CASE COMMENT REPORT

CASE NO. UDP-S24044

CASE:	UDP-S24044
MEETING DATE:	January 25, 2024
REQUEST:	Site Plan Level II Review: Site Plan Amendment with Design Deviation Requests to Increase Building Floorplate and Reduced Tower Stepbacks for Mixed-Use Development with an Additional 22 Residential Units Totaling 502 Units with Height Bonus Incentive to Increase Building Height to 85 feet in the Northwest Regional Activity Center
APPLICANT:	Sunshine Shipyard, LLC. And Gaddis Properties, LLC.
AGENT:	Stephanie Toothaker, Esq.
PROJECT NAME:	The Arcadian Amendment
PROPERTY ADDRESS:	640 NW 7th Avenue
ZONING DISTRICT:	Northwest Regional Activity Center-Mixed Use east (NWRAC-MUe)
LAND USE:	Northwest Regional Activity Center
COMMISSION DISTRICT:	2 – Steven Glassman
NEIGHBORHOOD ASSOCIATION:	Progresso Village Civic Association
CASE PLANNER:	Lorraine Tappen

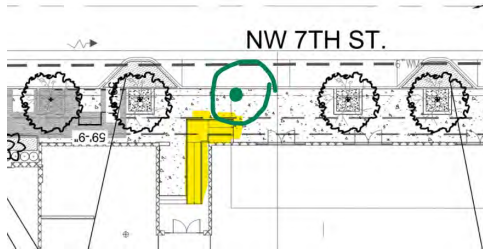
7. The use of structural soil is required in paved sites to provide adequate soil volumes for tree roots under pavements, as per ULDR Section 47-21.13. Structural soil details and specifications can be obtained at <http://www.hort.cornell.edu/uhi/outreach/index.htm#soil> This is to be provided at a minimum of 8' radii of tree trunks, and is to be consistently illustrated and noted on landscape, site and civil plans.

- a) Demonstrate hashing on landscape, site, and civil plans as to the extent of use of the Structural Soil. Hashing on landscape plans appears to be from previous submittal and does not match new site layout. Please revise.
 - b) Provide Structural Soil Detail and composition.
8. Utilities and site amenities such as walkways, ramps, flagpoles, transformers, fire hydrants, sewer and water supply lines, trash enclosures, and similar items located on the site shall not be placed adjacent to, in, or under required tree planting areas, as per ULDR Section 47-21.12. Confirm with civil, site and life safety plans that utilities and site amenities are not causing conflicts with proposed landscaping. Where conflicts exist, shift the utility and/or site amenities. See example of conflict below along NW 7 Street to be revised:

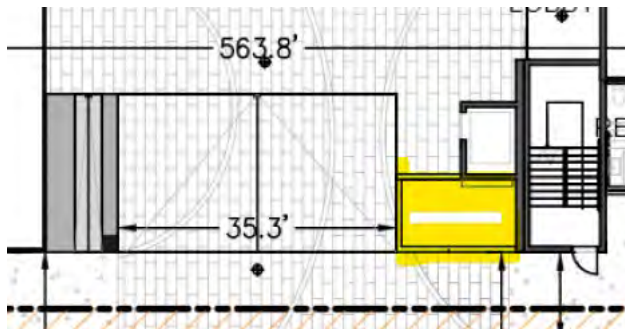
- f. Clarify ramp (?) highlighted below on western façade west of the pickleball court. Ramps cannot be located in the sidewalk clear path. Integrate access into building façade.
